Subject: Submission of documents for clarification as sought by EAC, MOEF&CC during EC meeting held on dated 26th June 2019 for EC for Proposed 1x660 MW based Coal Supercritical Sagardighi Thermal Power (Phase-III Expansion Unit–5, Village Manigram, Chandpara, Kanchanpara, Harirampur, at District Murshidabad, West Bengal

CLARIFICATIONS

Proposed 1x660 MW based Coal Supercritical Sagardighi Thermal Power (Phase-III Expansion Unit–5, Village Manigram, Chandpara, Kanchanpara, Harirampur, at District Murshidabad, West Bengal

(F.No.J-13012/01/2019-IA.I(T) & Proposal no.IA/WB/THE/107519/2019)

PREPARED		JOB NO	12A05
CHECKED		SCALE	NTS
APPROVED		DATE	
DWG.NO.	12A05–DWG–M–0010–A	SHEET 1 OF 1	REV. 00

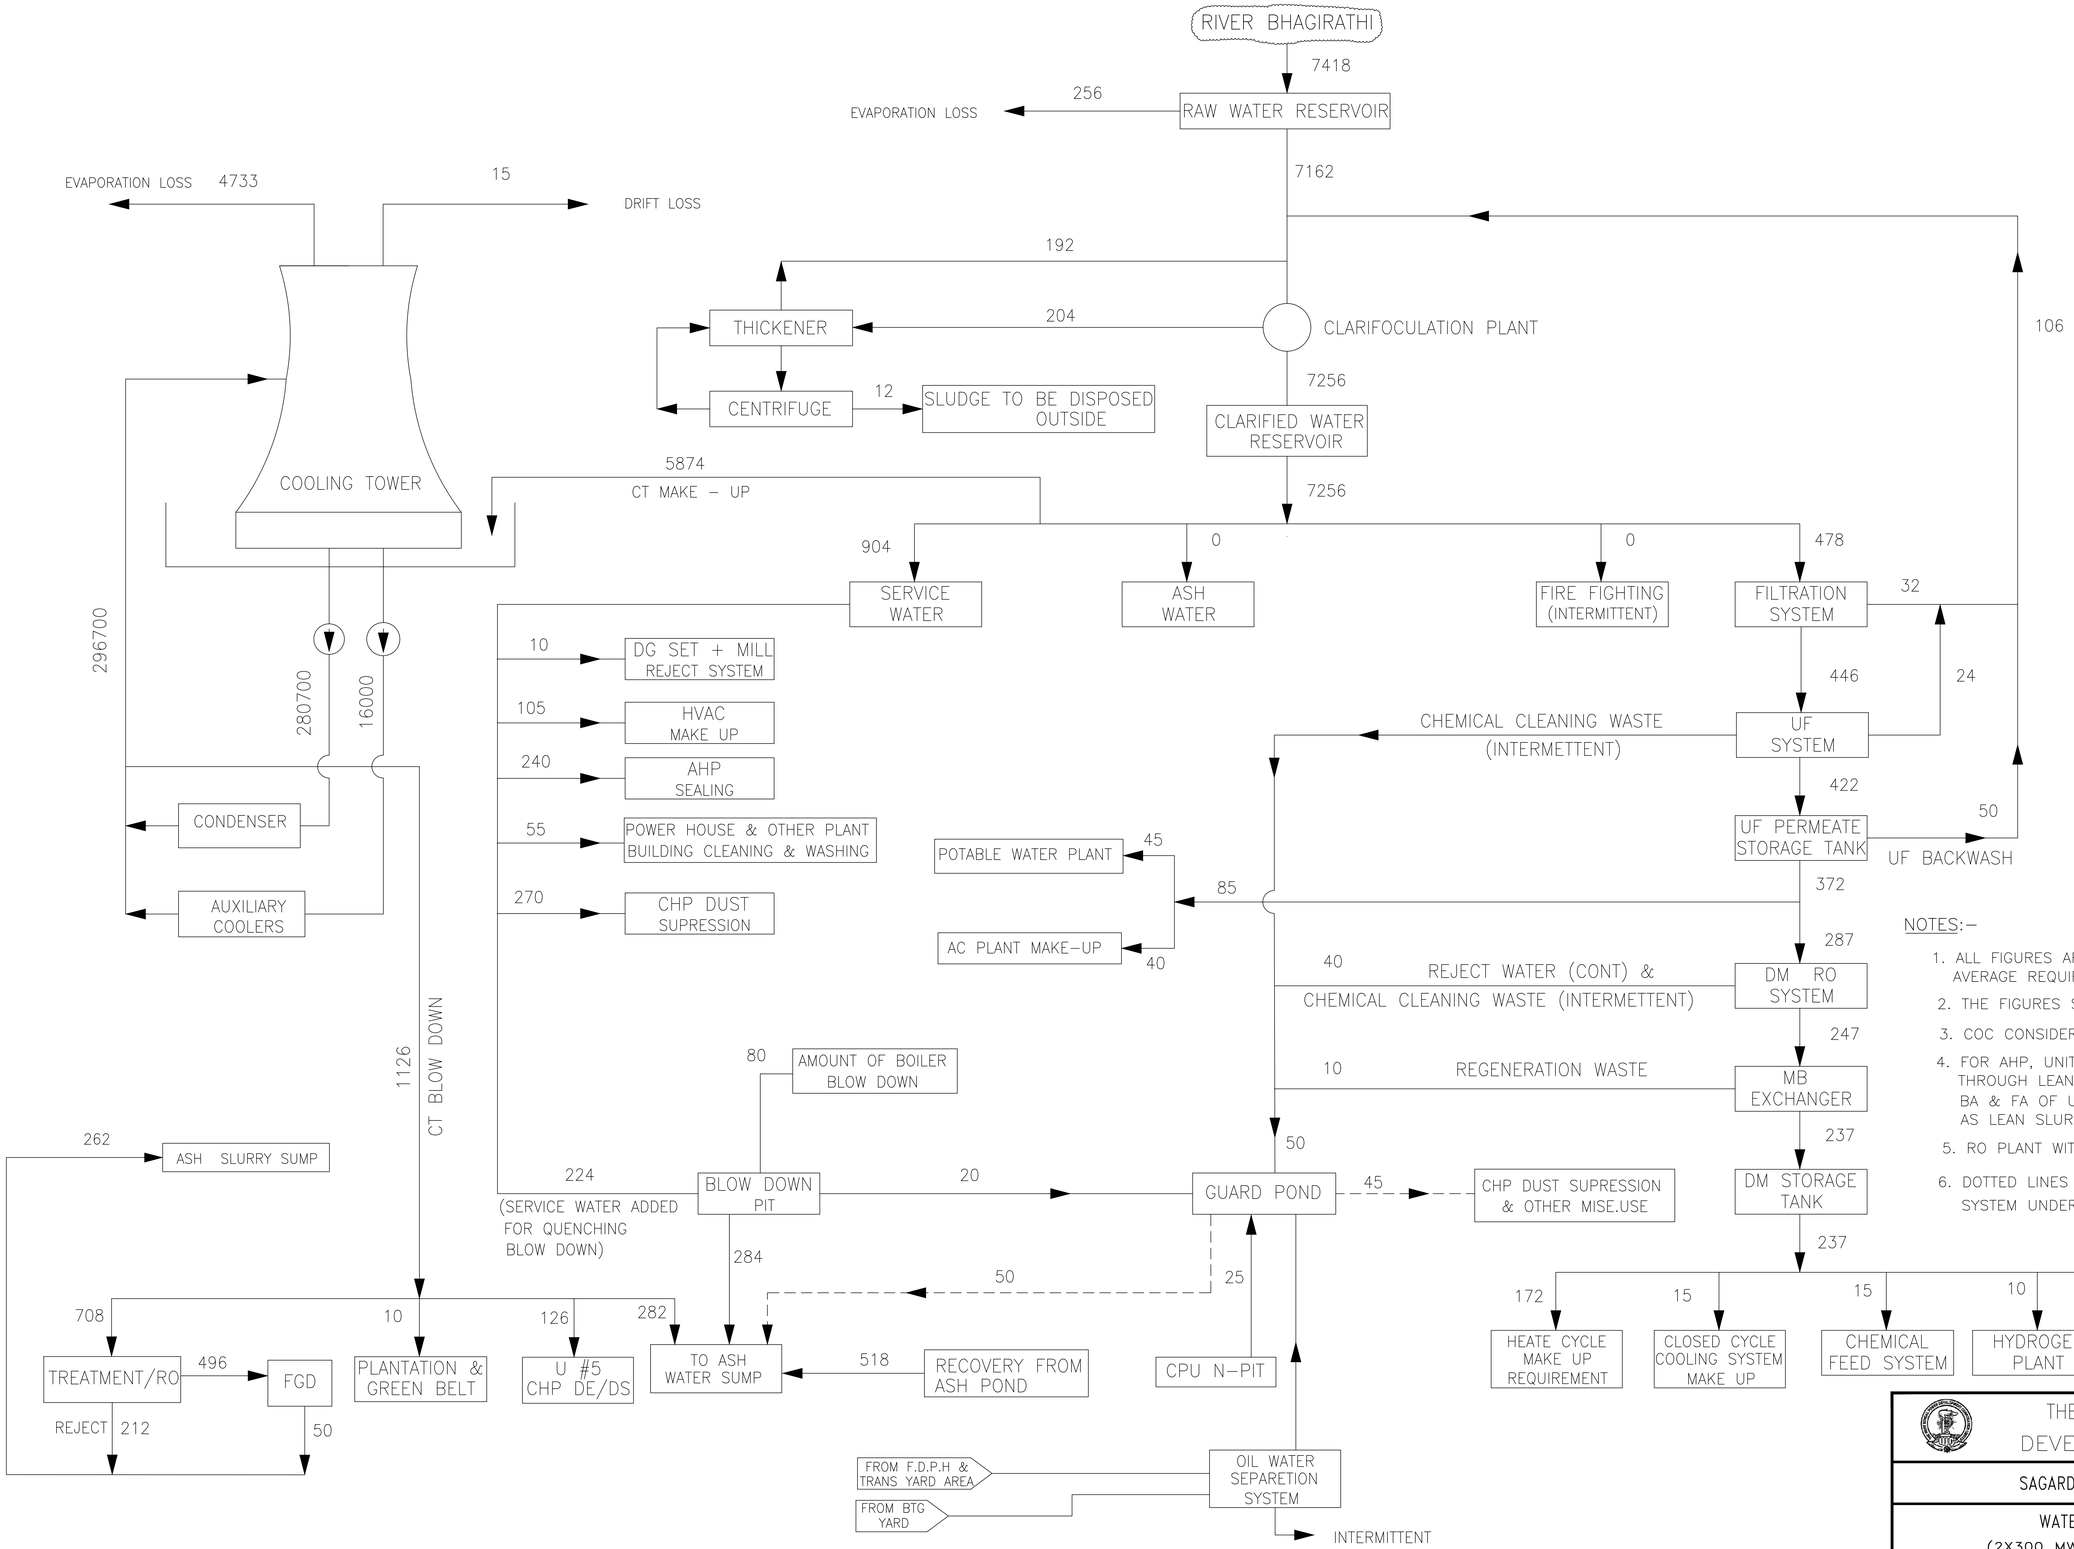
VI. It has been mentioned that evaporation loss is 4733 m3/hr which accounts to be 66% of the total water requirement which is not reasonable. The revised water balance diagram with all details shall be furnished.

Water balance diagram which we have submitted is a composite diagram for five unit of capacity 2260MW and it shows that evaporation loss is 4733 m3/hr from the cooling water circuit of 296700 m3/hr. Generally evaporation loss is 2-3% of circulating water. In this case evaporation is only 1.58% which is quite reasonable.
